To: Joe Schmitz, City of Goodyear
CC: Christopher Baker, Katie Wilken
From: Meritage Homes
Date: July 19, 2017
Re: Case No: 16-210-00005 -- Vistas at Palm Valley – Site Plan Modification Transmittal

Summary of Changes

VISTAS AT PALM VALLEY

EXHIBIT 03 PRELIMINARY SITE PLAN

EXHIBIT 4A

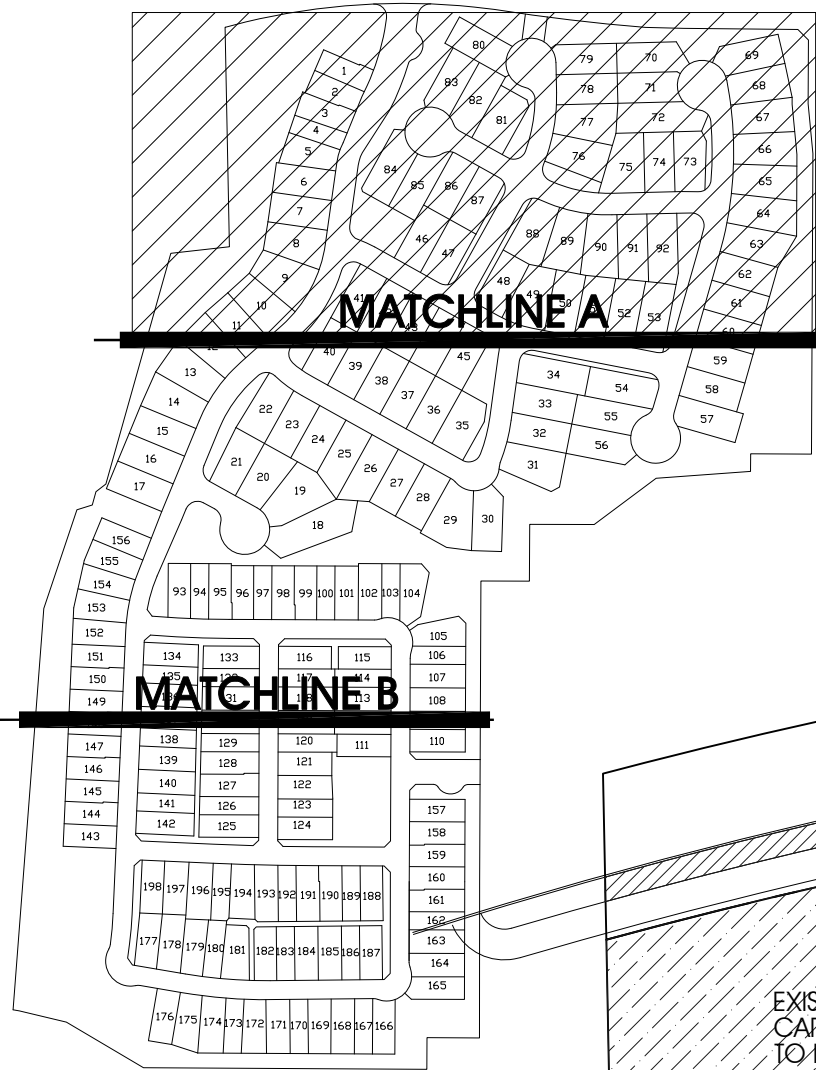
- 1) Lot # 69 was deleted from Parcel A SF-D parcel. This lot was located on the SWC of Litchfield Road and Palm Valley Boulevard. The revised SF-D lot count now stands at 86 lots versus the previous version which reflected 87 SF-D lots.
- 2) Expanded the single-story lot restriction to include all homes adjacent to or abutting Litchfield Road or Palm Valley Boulevard. The single-story lot restrictions in Parcel A now include lots 1, 15-17, 57-68, 70, 79, and 80 as depicted on the updated Exhibit 3 Preliminary Site Plan. There were no changes to Parcel B single-story restrictions.
- 3) As part of the Site Plan revisions, the Preliminary Concept Landscape Plans have been updated accordingly and are provided for reference.
